I received your February 21 letter. You express your client's concerns about the possible effects of the proposed SH 121T on access to and from University Centre I to Vickery Boulevard. You also request that Vickery Boulevard remain a two-way street, that the City provide schematic drawings of the proposed one-way travel, that the City supply you "any future proposals or revisions [to Vickery Boulevard]," and that the City notify you of "any meetings that will affect or concern access to University Centre I."

Re: State Highway 121T/University Centre II

RE: Letter of comment for Proposed 121 Toll Road

In Re: Fort Worth Country Day School's written comments and questions regarding
environmental study for SH121T

Project Layout

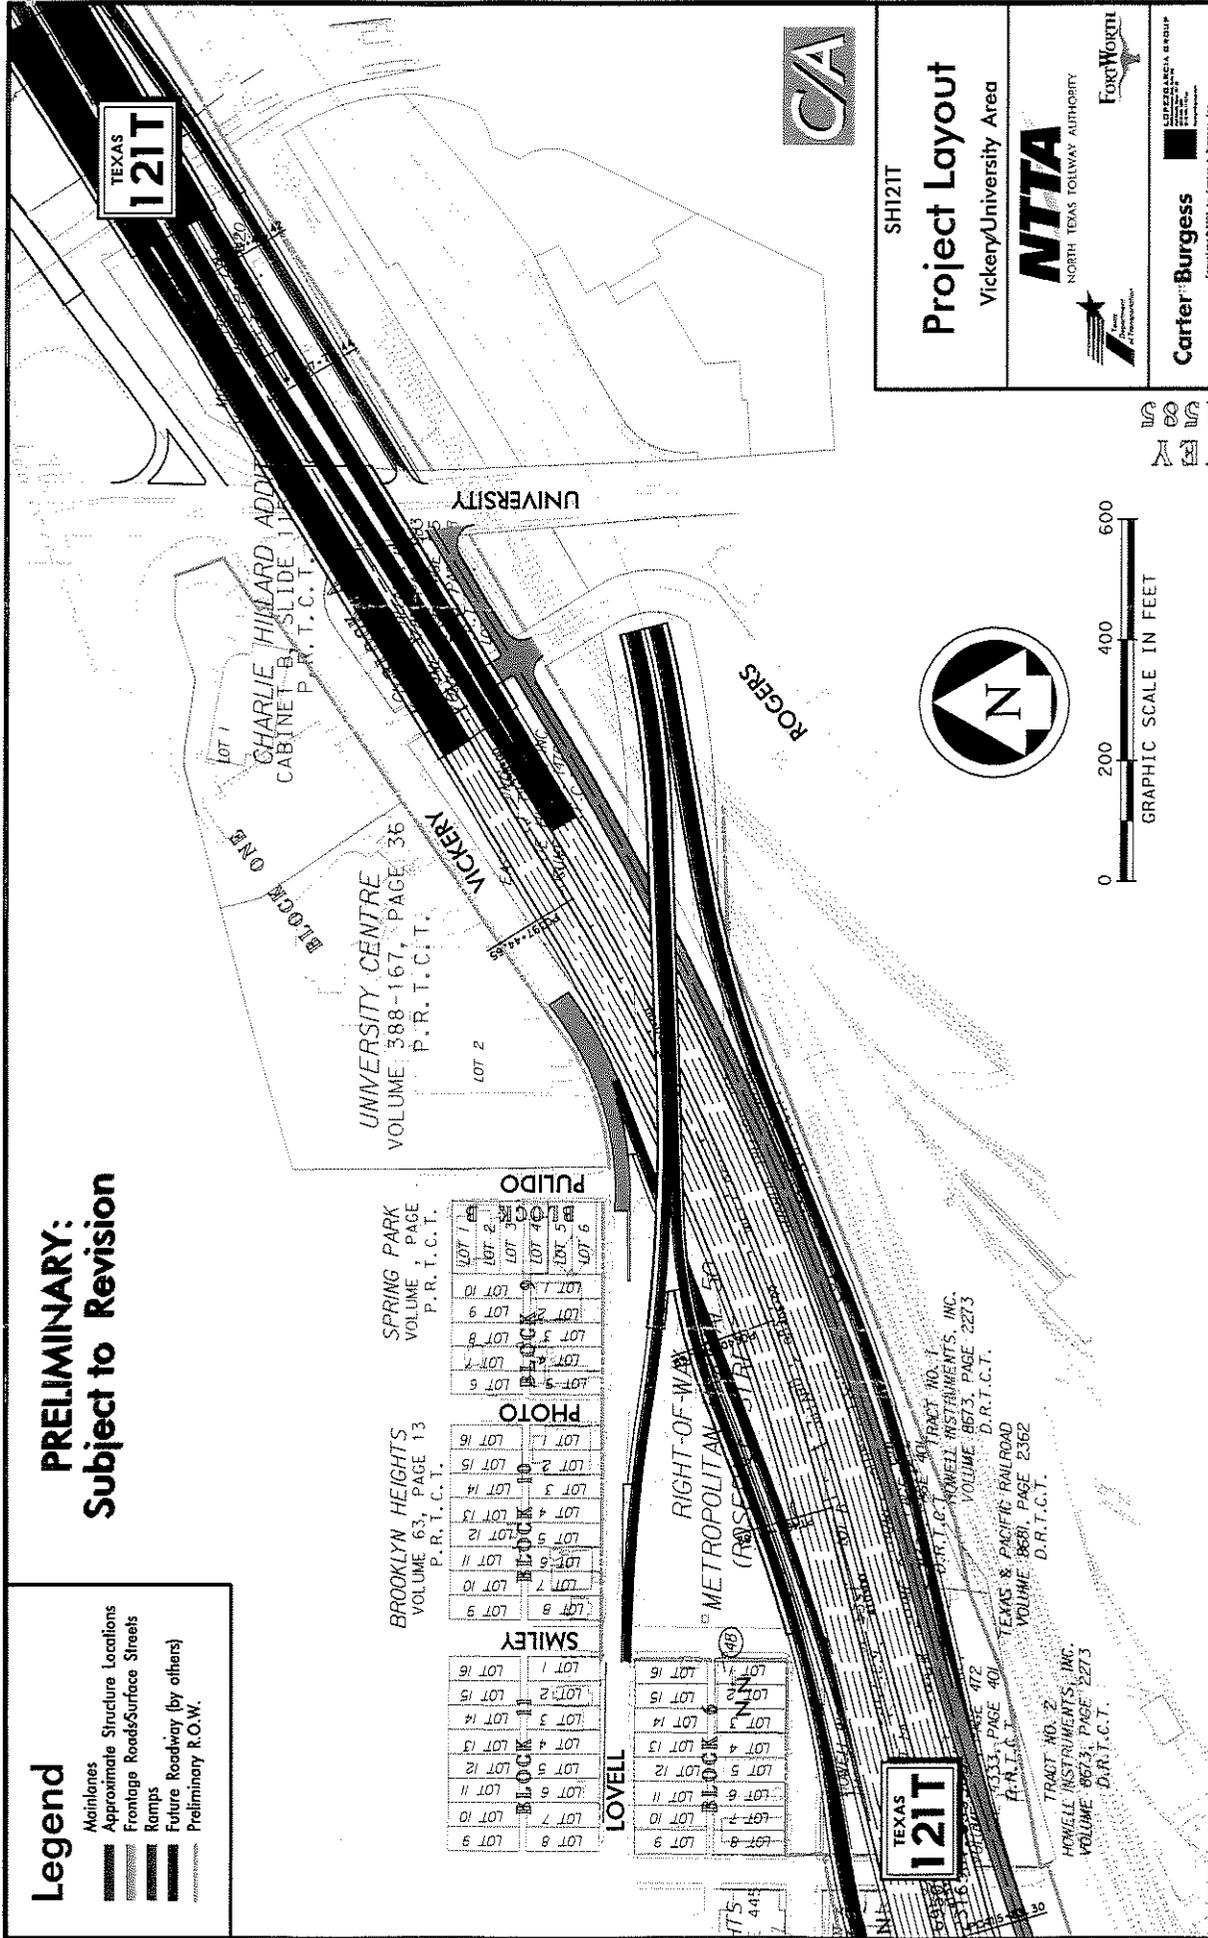
I understand your concern to be that the conversion of Vickery Boulevard from a two-way street to a one-way street will "result in taking an important right away from the tenants and reduce the value of the building." While I can understand that you believe that circuitry of travel may be increased, I do not believe that the increase is a material and substantial impairment of access to the building and its parking facilities.

In addition, Vickery Boulevard must become one way for safety reasons. Vickery Boulevard will serve as an entranceway to SH 121T. Two-way traffic on Vickery Boulevard would create an unreasonable risk to the traveling public. Therefore, Vickery Boulevard should be changed to one way as in the current design. In this connection, please see the enclosed schematic that shows the proposed construction of SH 121T. I believe this is the schematic that you requested. If it is not, please let me know. While my staff and I are willing to work to explore access issues on this project with any affected property owners,

the City believes that the circuitry of travel and safety concerns do not favor keeping Vickery Boulevard two way.
